**Exhibit B**

**Reliability Standard submitted for Approval**

- 1. Title:** Facility Connection Requirements
- 2. Number:** FAC-001-1
- 3. Purpose:** To avoid adverse impacts on reliability, Transmission Owners and Generator Owners must establish Facility connection and performance requirements.

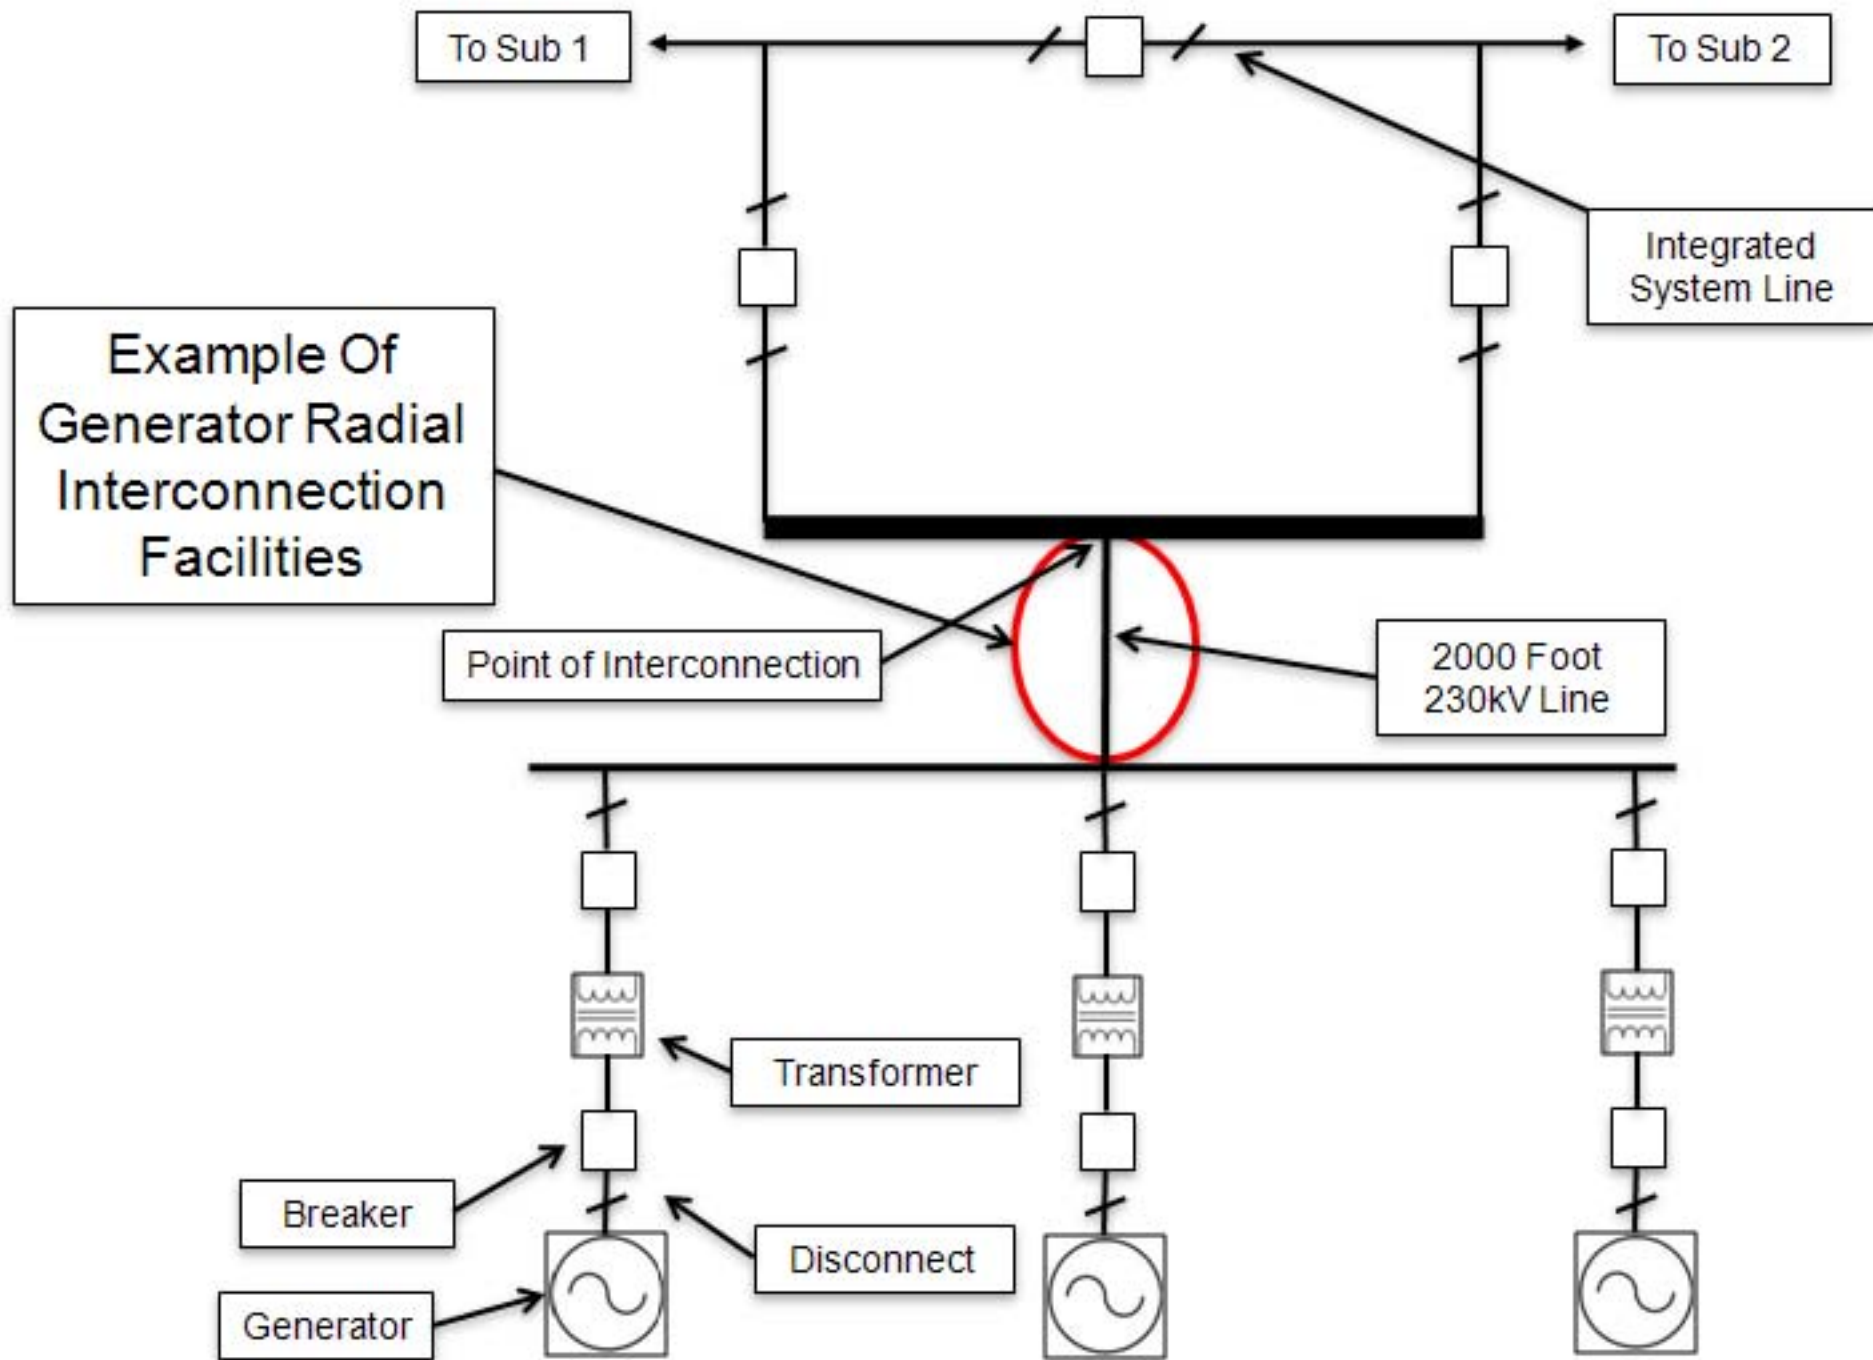
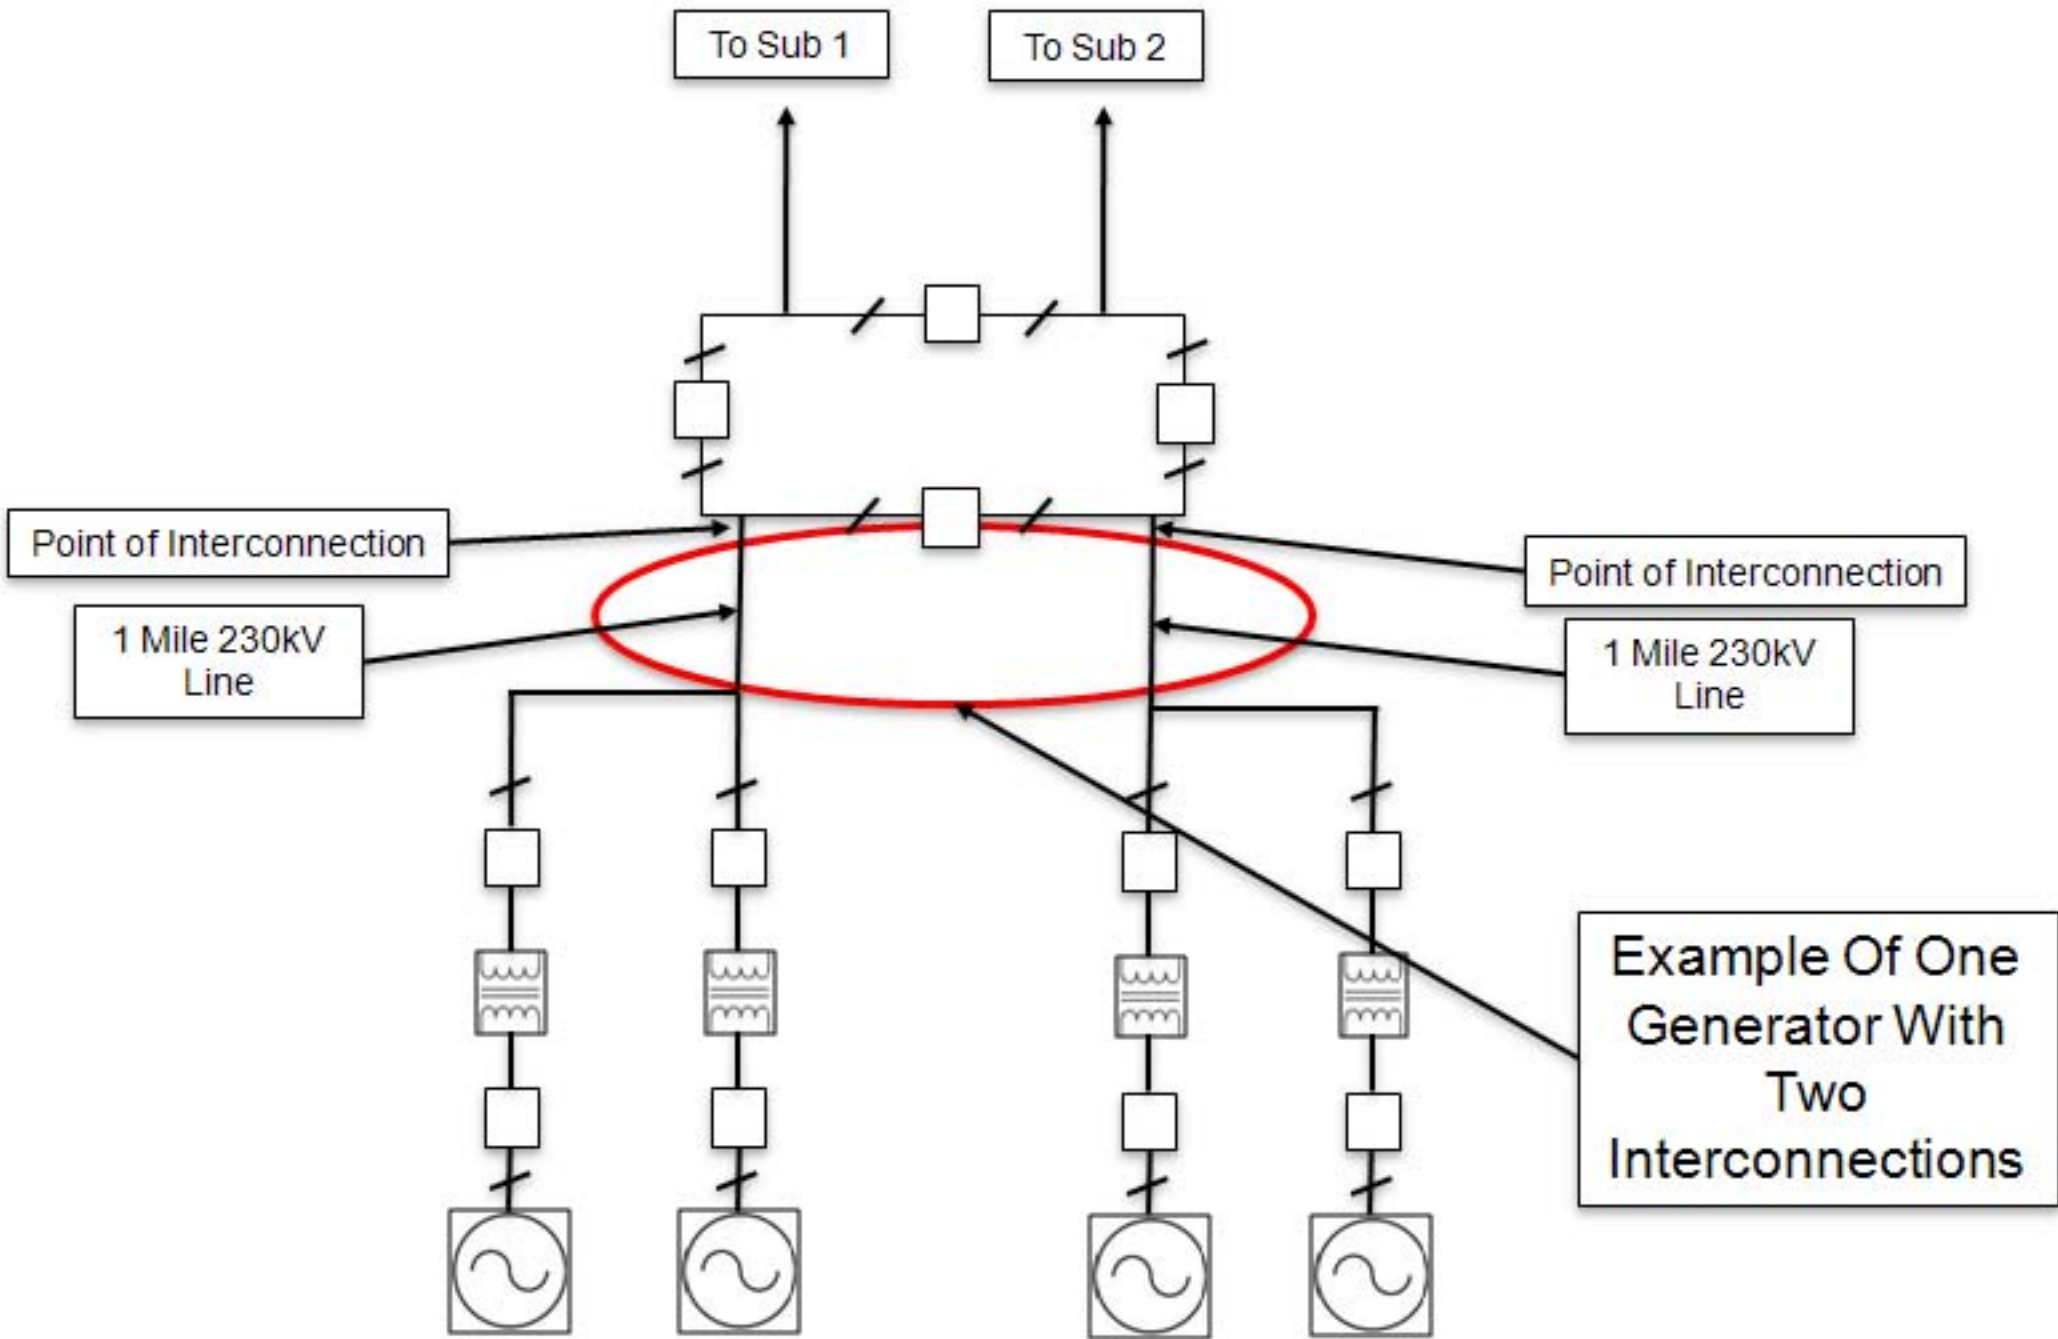
The SDT can only work within the standards development process. We cannot address other regulatory issues such as FERC-mandated open transmission access (Order 888 and subsequent) or state or provincial jurisdiction over generation or transmission assets. While we acknowledge these

mechanisms exists and may come into play in the scenarios described in the proposed FAC-001-1, we as the SDT can only deal within the context of reliability standards. For this reason, R2 indicates that FAC-001-1 applies only when a Generator Owner has an executed Agreement to evaluate the reliability impact of interconnecting a third party Facility to the Generator Owner's existing Facility. The SDT's reasoning here is that if the owner of the existing generator interconnection Facility agrees, or is compelled, to allow a third party to interconnect, and can do so using existing agreements, contracts, and/or tariffs (and thereby avoid having an executed Agreement to evaluate the reliability impact of interconnecting third party Facility to the Generator Owner's existing Facility), and thus avoid having to develop its own connection requirements or perform impact studies, it will. In this example, it is likely that the existing Transmission Owner, Transmission Planner, and/or Transmission Service Provider processes and Agreements will be utilized and the purpose of FAC-001-1 will be met without applying this standard to the Generator Owner.

If, on the other hand, the owner of the existing generator interconnection Facility agrees, or is compelled, to allow a third party to interconnect, but cannot do so without having to develop its own connection requirements or perform impact studies, the SDT believes that the potential for a reliability gap exists. This might occur, for instance, if the owner of an existing generator interconnection Facility was compelled to allow interconnection and to implement open transmission access. In this example, (under FERC Order 888 and subsequent orders), the existing interconnection owner becomes a Transmission Service Provider and is required to have an Open Access Transmission Tariff (OATT). FERC's pro forma OATT requires the Transmission Service Provider to, among other things, perform system impact and feasibility studies. In order to do so, such studies must be coordinated with other Transmission Service Providers and Transmission Planners. And, to further complicate the issue, the SDT has been informed that in Texas, a Generator Owner is not allowed to own transmission.

Clearly, these issues are complex and not all are within the jurisdiction of federal or provincial regulators. For these reasons, the SDT took the only approach it found workable. If, and only if, the existing owner of a generator interconnection Facility has an executed Agreement to evaluate the reliability impact of interconnecting a third party Facility to its existing generation Facility would the proposed FAC-001-1 apply. The SDT believes that this is most likely to occur if the owner of an existing generator interconnection Facility is compelled to allow a third party to interconnect and adopt open transmission access. However, the SDT cannot be certain this is the only example and it therefore proposes to add this new requirement to FAC-001-1. In doing so, the SDT acknowledges that the Generator Owner may not, at the time it agrees or is compelled to allow a third party to interconnect, have the necessary expertise to conduct the required interconnect studies to meet this standard. However, the SDT believes that, upon executing such Agreement, the Generator Owner will have to acquire such expertise. How the Generator Owner chooses to do so is not for the SDT to determine. The SDT is tasked with identifying potential reliability gaps and addressing such gaps through the standards development process.
